**Western Star
Service Bulletin**

SB-10058907-7203

Description of Revisions: *This bulletin replaces the version dated July 2015. **Figure 3** has been revised to show the correct location of wire 36A.*

Fig. 1, Turn Signal Switch

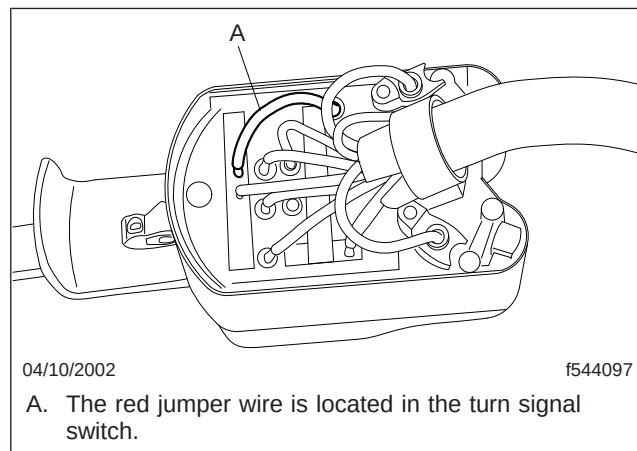
To enable 4-way override on all Western Star vehicles equipped without self-cancelling turn signal switches, remove the jumper wire located in the turn signal switch and tape it back. See **Fig. 1**.

Fig. 2, Auxiliary PDM Location

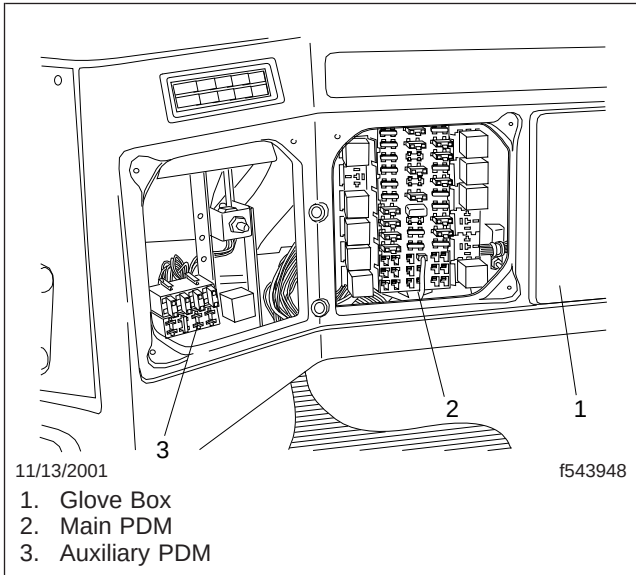
On 4700 models with self-cancelling turn signals, remove wire 36A (red with a white stripe) from cavity 85 on the auxiliary PDM, and tape it back. See **Fig. 2** and **Fig. 3**.
